The staff recommends that the Toledo City Plan Commission recommend approval of SUP-5006-24, a Special Use Permit for gas station at 1950 S. Reynolds Road, to the Toledo City Council, for the following **three (3) reasons**:

SPECIAL USE PERMIT  
TOLEDO CITY PLAN COMMISSION  
REF: SUP-5006-24  
DATE: July 11, 2024  
TIME: 2:00 P.M.

## SPECIAL USE PERMIT SHEETZ CONVENIENCE STORE

1950 S. REYNOLDS ROAD  
IN THE CITY OF TOLEDO, LUCAS COUNTY, OHIO

# SITE PLAN

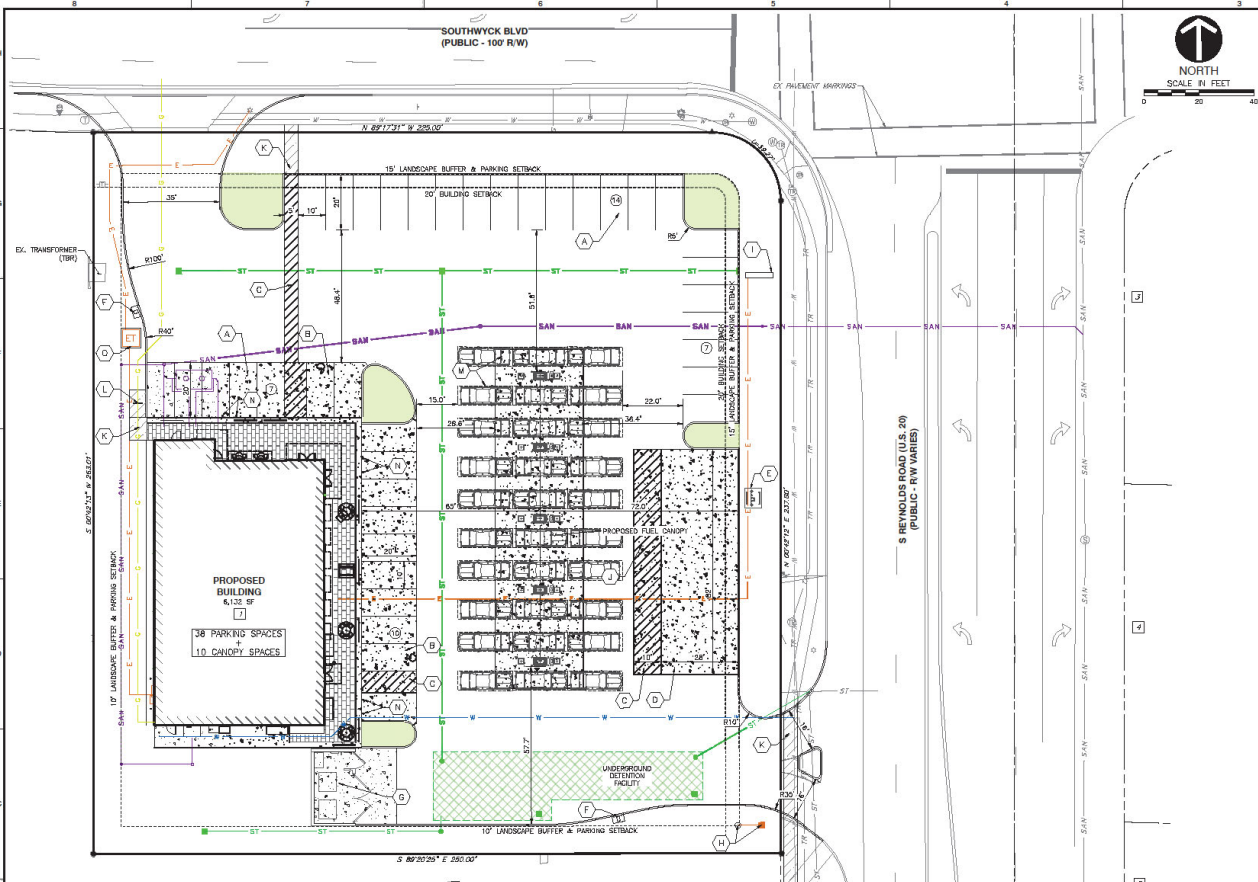
The submitted site plan and elevation drawings meet the above design and dimensional standards. Two air stations are noted on the site plan. However, to be compliant with this section, they must be free of charge to customers which is listed as a condition of approval. Staff is not recommending the hours of operation be limited since the surrounding land uses and zoning are commercial or industrial in nature.

The site will have two access drives, one from Reynolds Road and one from Southwyck Boulevard. The access drive on Reynolds Road will be limited to a right-in/right-out driveway. The building will face Reynolds Road and parking will be located along the north and east building facades. Additional parking will be located along the north and a portion of the east property lines. There are existing sidewalks along both Southwyck Boulevard and Reynolds Road. A connecting walkway from the north side of building to the sidewalk on Southwyck Boulevard is being provided. Following are parking and circulation related requirements per TMC§1107 - Parking, Loading, and Access:

- **Pedestrian Circulation at Building** - A brick paver walkway is proposed along the north and east sides of the proposed building. Outdoor seating areas are proposed within this brick paver walkway that include a mix of table sizes and types with an ornamental fence segment between the tables and the parking spaces. The placement of two tables and one picnic bench along the east side of the building obstructs pedestrian circulation and does not provide a clear path. This area will need to be redesigned to ensure that there is a clear pedestrian path around the building. A revised site plan shall be submitted depicting the unobstructed pedestrian path and is listed as a condition of approval.

- **Wheel Stops** - Per TMC§1107.1907, whenever a parking lot extends to a property line, sidewalk, planting strip, or building, a wheel stop device consisting of a concrete stop, a permanent concrete curb, an expanded sidewalk or other suitable restraint as approved by the Planning Director must be installed. Wheel stops are required for the thirty-eight (38) marked parking spaces. No wheel stops are depicted on the submitted site plan; therefore, wheel stops shall be provided and depicted on a revised site plan as a condition of approval.

24. Accessible parking signage is required to be shown and must comply with TMC§ 1107.1704.
25. Gas pumps must be moved 3' to the east to allow room for a two-way drive aisle with the gas pump stacking per TMC§1107.1911.
26. Islands at the corners of the building sidewalk must be reduced to no more than 18' off of sidewalk.

34. Sidewalks shall be provided along all public streets in commercial districts per TMC§1107.1303. **Acceptable as depicted.**
35. Clear pedestrian pathways shall be provided on the site. The site plan depicts tables along the east side of the building that obstruct pedestrian circulation and does not provide a clear pedestrian path. **Not acceptable as depicted on site plan submitted. The area shall be redesigned to provide a clear pedestrian path and shown on a revised site plan.**

36. Wheel stops shall be provided whenever a parking lot extends to a property line, sidewalk, planting strip, or building per TMC§1107.1907. Wheel stops are required for the 38 proposed marked parking spaces. Wheel stops are not provided that meet this requirement. **Not acceptable as depicted on the site plan submitted. Approved wheel stops shall be provided and depicted on a revised site plan.**

POLE SIGN  
DETAILS

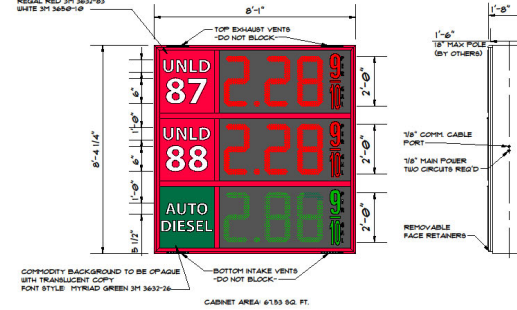
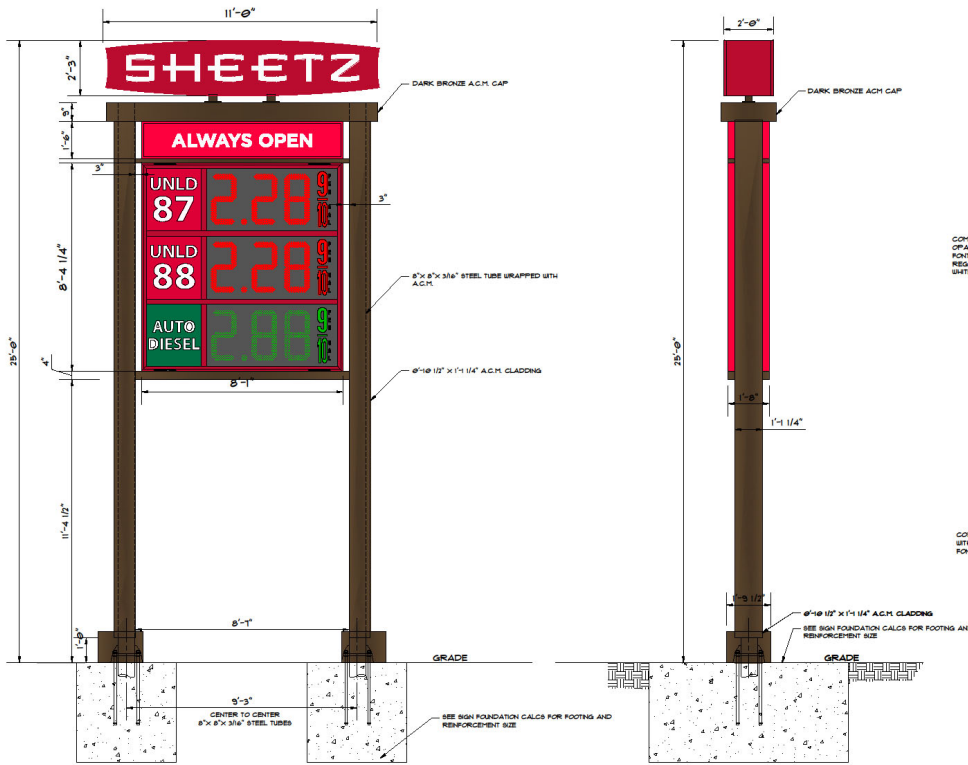
A detail sheet for a sign with visible support poles along Reynolds Road was submitted with project plans. Signs with visible support poles are not permitted. Instead, a high-profile ground sign is permitted. A high-profile ground sign is supported on a full base foundation that does not allow air to pass beneath. The sign includes a digital price board with two (2) colors. Since two (2) colors are proposed, the sign is considered an electronic message center and must meet TMC§1113.0506. Wall signs are also proposed on the main building. All of the proposed signage is required to meet TMC§1113.

42. All proposed signage shall meet TMC§1113 - Signs. **Not acceptable as depicted on sign plans submitted. A revised sign plan shall be submitted for review and approval.**
